INSPECTION OF IMPROVEMENTS TO THE KHOWST CITY ELECTRICAL POWER SYSTEM:

SAFETY AND SUSTAINABILITY ISSUES WERE NOT ADEQUATELY ADDRESSED

Sustainability Issues Were Not Adequately Addressed (SIGAR Inspection 09-1)

Photo 1: Power Plant 1 PRE-IMPROVEMENT Condition of Power Plant 1, Spring, 2008 (Courtesy of Khowst PRT)

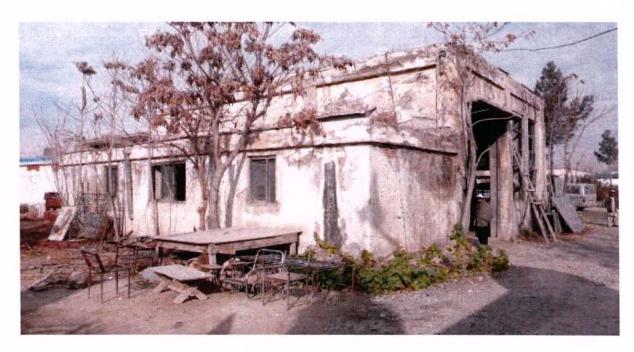
The existing power plant (Power Plant 1) was operating with two 400 kilowatt (kW) diesel fuel generators that had been donated and installed in 2003-2004 through the United Nations Development Program (UNDP) national electrification project and an old diesel generator of Czechoslovakian design that dated back to the 1950s.² Although the combined potential capacity of these three generators was approximately 1,124 kW, the power output was unreliable and on average far less than the amount required by users. As part of its initial assessment of Power Plant 1, the PRT identified several safety concerns:

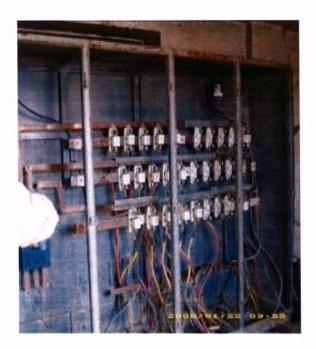
- The electrical power cables ran directly from an open distribution panel, across the floor to the generators. As a result, local plant operators were routinely exposed to a significant shock hazard. (Photos 2 and 3); and,
- The 20,000 liter fuel tank which was installed in 2003 as a part of the UNDP improvement program at the rear of Power Plant 1's main building was balanced on loose bricks and lacked a fuel spillage containment area. Additionally, defective hose fittings caused fuel to leak into the ground directly behind Power Plant 1 (Photo 4).

- Correct the safety hazards and other technical deficiencies noted in this report;
- Assign qualified personnel to provide oversight of the follow-on CERP projects to correct the safety hazards and technical deficiencies at the Khowst Power System.
- Provide training and mentoring of the power plant management and personnel to build capacity to address issues of long term maintenance and sustainability.
- Review its other CERP projects to determine if it is providing adequate project oversight and adequate training and mentoring to build capacity for long-term project sustainability.
